Service Bulletin

Bulletin No.: PI1161A

Subject: Fuel Gauge Does Not Read Full, Only Goes to 7/8 Full

Models: 2013 Buick LaCrosse, Regal Equipped with Engine RPO LUK
2013 Chevrolet Malibu LT or LTZ Equipped with Engine RPO LUK
2013 Chevrolet Malibu LS Equipped with Engine RPO LCV
Built Prior to August 26, 2013

3657668

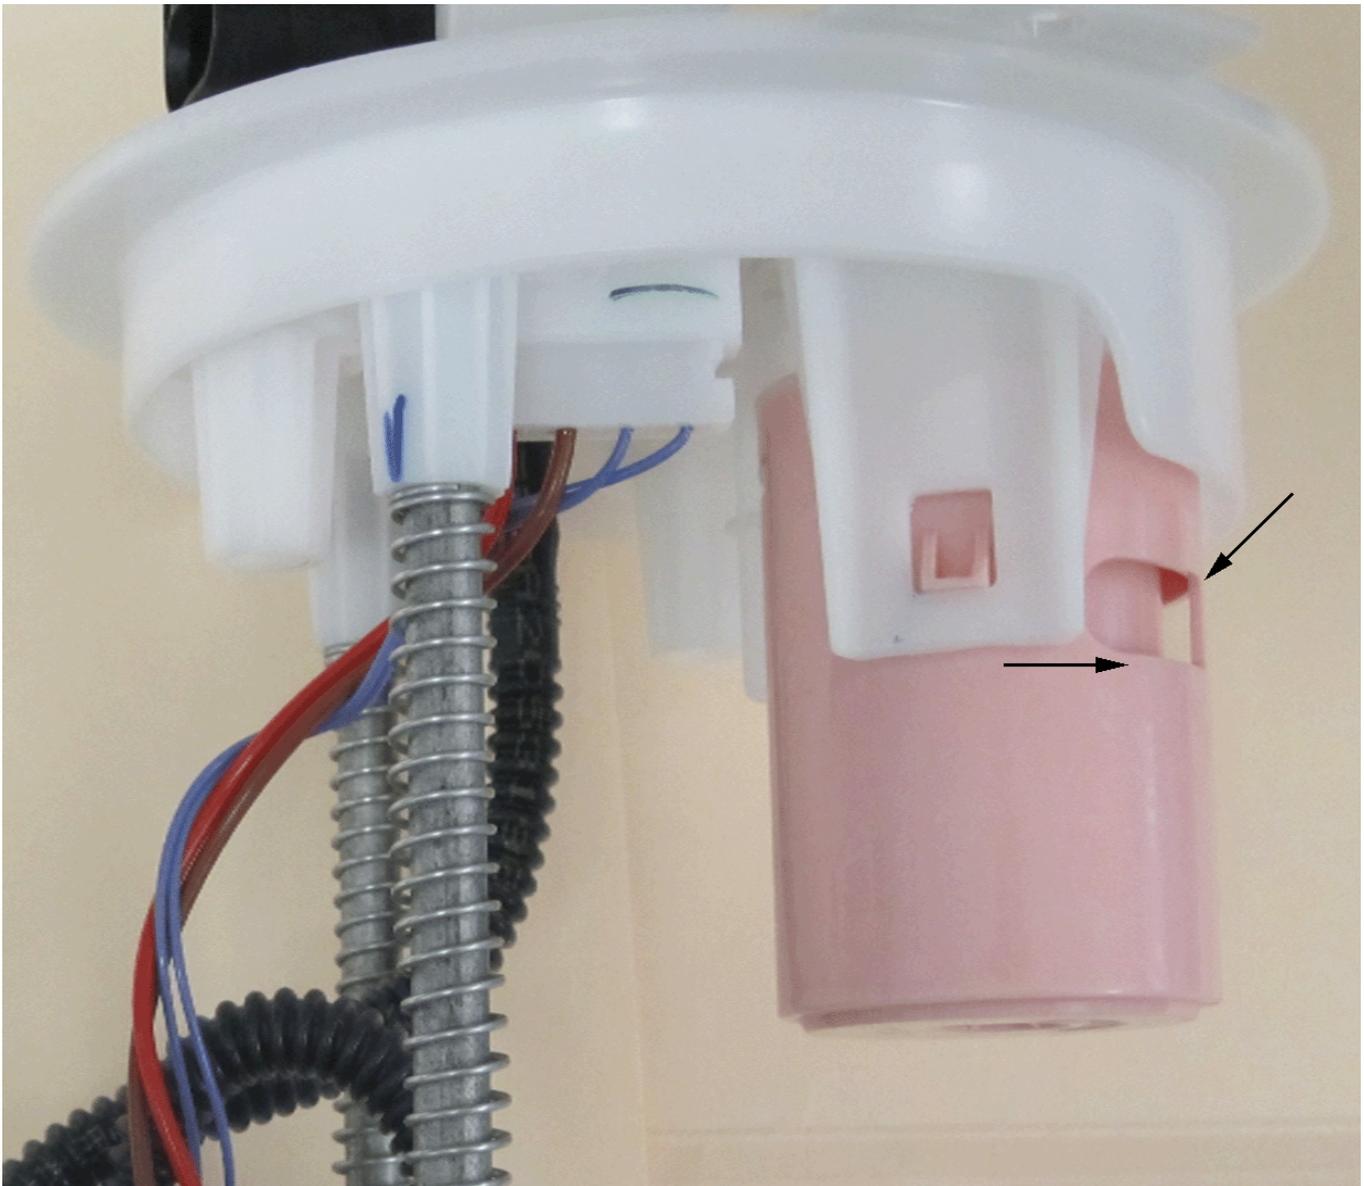
This condition may be caused by build variation of the fuel level sensor sending the incorrect fuel level value to the engine control module (ECM).

A new fuel fill shutoff valve and fuel level sensor have been released to address this concern.

Replace the fuel level sensor and shutoff valve with the new part numbers listed below. Use a plastic trim stick to pry the tabs out to unsnap the original shutoff valve. When replacing the shutoff valve, make sure the windows on the valve point out as shown in the illustration above.

Important: DO NOT lubricate the O-ring on the new shutoff valve.
